EBEY'S LANDING HISTORIC PRESERVATION COMMISSION
ISLAND COUNTY COMMISSIONERS' HEARING ROOM (Room 102B)
1 NE 6th St., COUPEVILLE, WA
AUGUST 28, 2025

Ebey's Landing National Historical Reserve
Certificate of Appropriateness
Connor Tasoff
304 NE Fifth St
COA-25-028

Ebey's Landing National Historical Reserve
Certificate of Appropriateness
Wood
433 Wanamaker Road, Coupeville
EBY-25-023

AFTER-THE-FACT REMODEL; CONDITIONS OF APPROVAL UPDATE

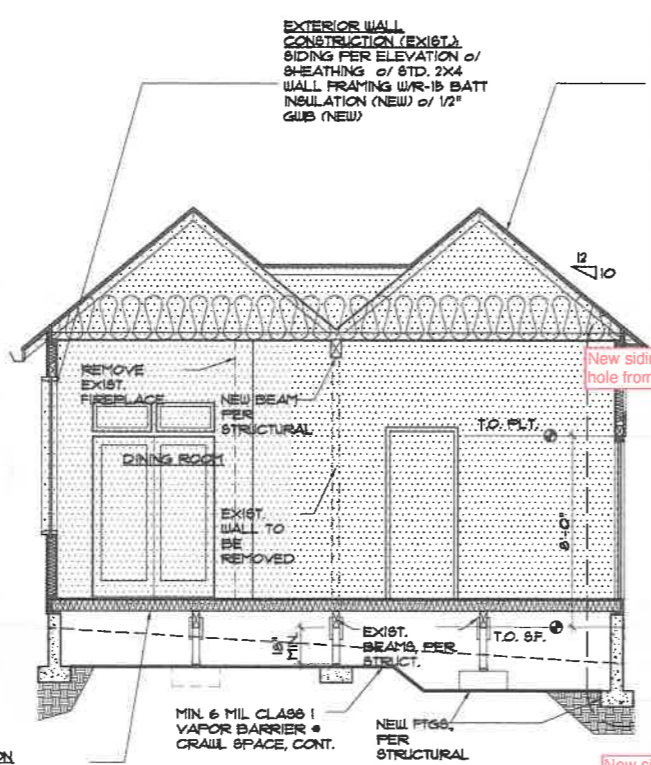
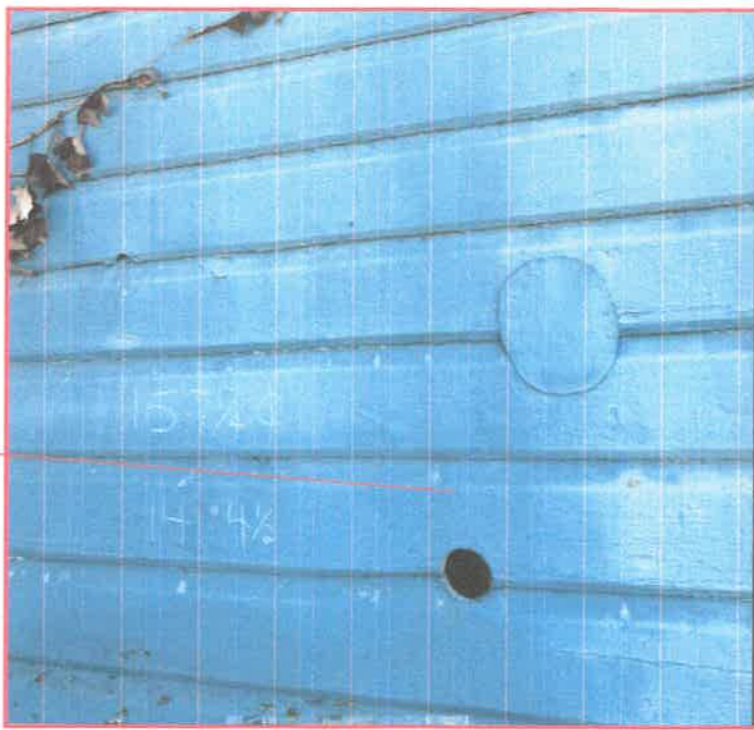
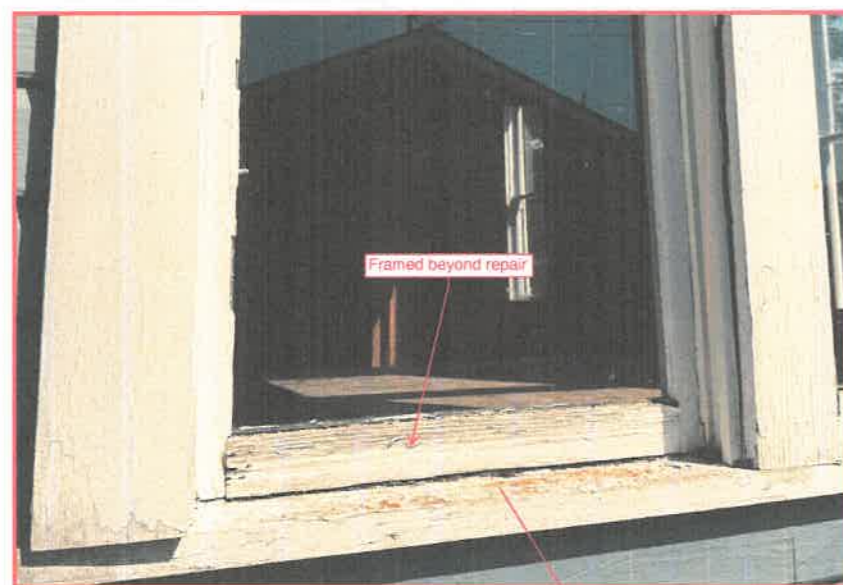
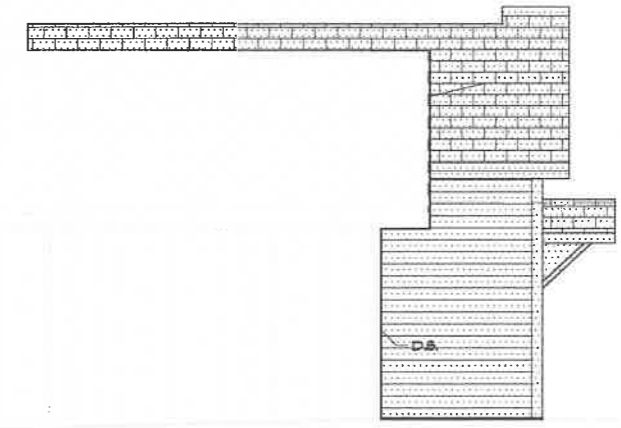
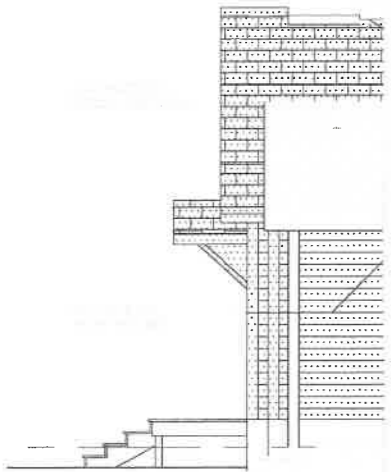
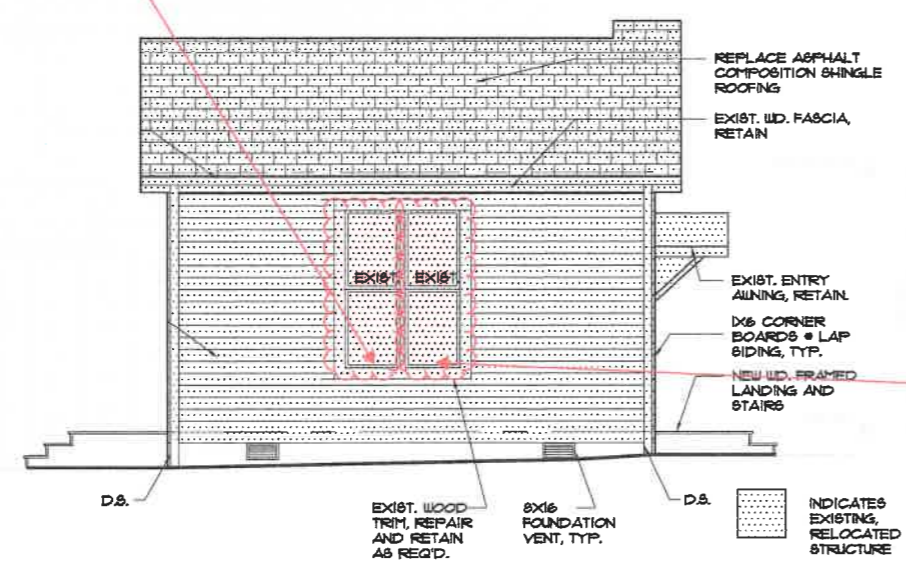
This entire area will require re-siding for 1) infill of the existing vent lines penetrations, and 2) infill of the existing window.

New siding required due to hole from electrical meter.

New siding required where required for removal during transport of structure. Material was not able to be salvaged given it's existing condition being buried in overgrown and soil at Front Street Lot. Typical for entire building perimeter.

Bump out was unable to remain in place during transport of the house. It has been re-framed and will be re-sided with dutch lap siding.

New siding required where required for removal during transport of structure. Material was not able to be salvaged given it's existing condition being buried in overgrown and soil at Front Street Lot. Typical for entire building perimeter.

Framed beyond repair

Window glazing falling out and failed, typical at most windows.

Sill rotted and failing

REPLACEMENT FRENCH DOOR

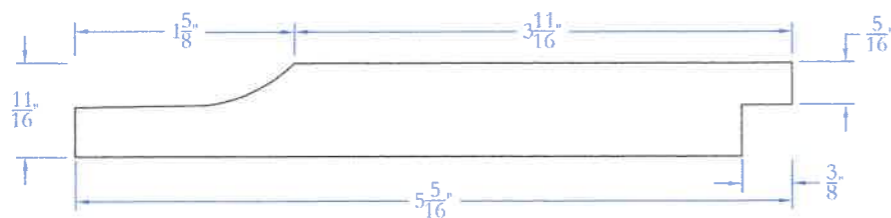
10.	In historic buildings, avoid modern window types such as picture windows or sliding glass patio doors on the main façade, unless they were original to the house. <i>Applicant proposes to replace the existing French doors with smooth, fiberglass French doors. This side of the structure is the rear (north-facing) façade and does not face the right-of-way.</i>
11.	Preserve the position, number, and arrangement of original windows and doors. <i>The applicant proposes to retain all original door and window openings, with the exception of a recently added window on the rear (north-facing) façade, which they would like to completely remove. Staff finds this request conforms to the guideline.</i>

REPLACEMENT ENTRY DOOR MATCH

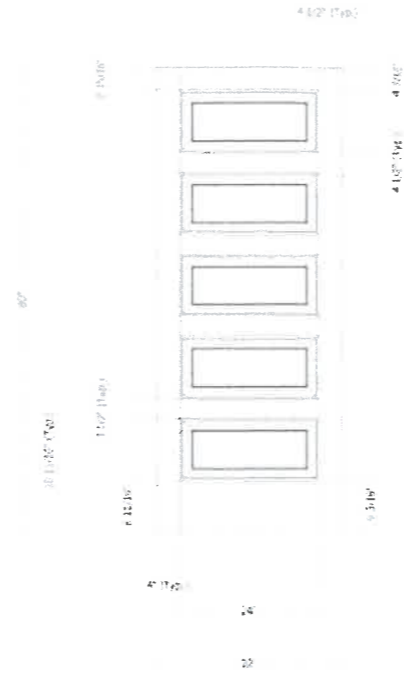
Guideline	Staff Analysis
1.	Doors are often important character-defining features. Refurbish and re-use original doors and door hardware whenever possible. If replacement is necessary, match the material, style, and detailing as closely as possible. <i>Applicant proposes to replace the front door with a new, similarly styled wooden door. Staff finds the replacement door to conform with the guideline. See Windows #10 above for discussion of French doors.</i>

REPLACEMENT WINDOWS

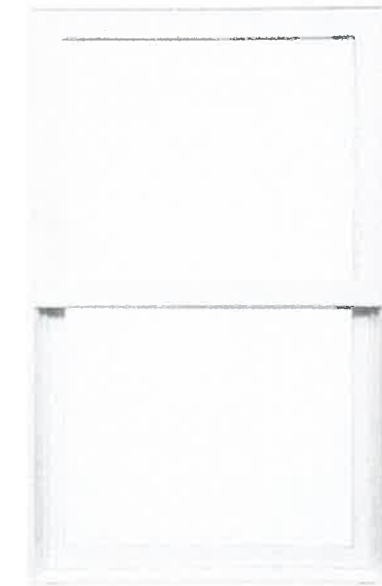
Guideline	Staff Analysis
1.	<p>Repair rather than replace wood windows, if at all possible.</p> <p><i>Applicant states that repairing the existing windows is too expensive and not cost-effective for the intended use of the structure.</i></p>

2.	<p>If a window is so deteriorated that replacement is necessary, replacement windows should be of wood, if that is the existing material. Replaced window sash shall closely resemble the original.</p> <p><i>Applicant states that vinyl is the most energy-efficient, cost-effective option available for their budget and the anticipated use of the structure. Staff agrees with the use of vinyl replacement windows.</i></p>
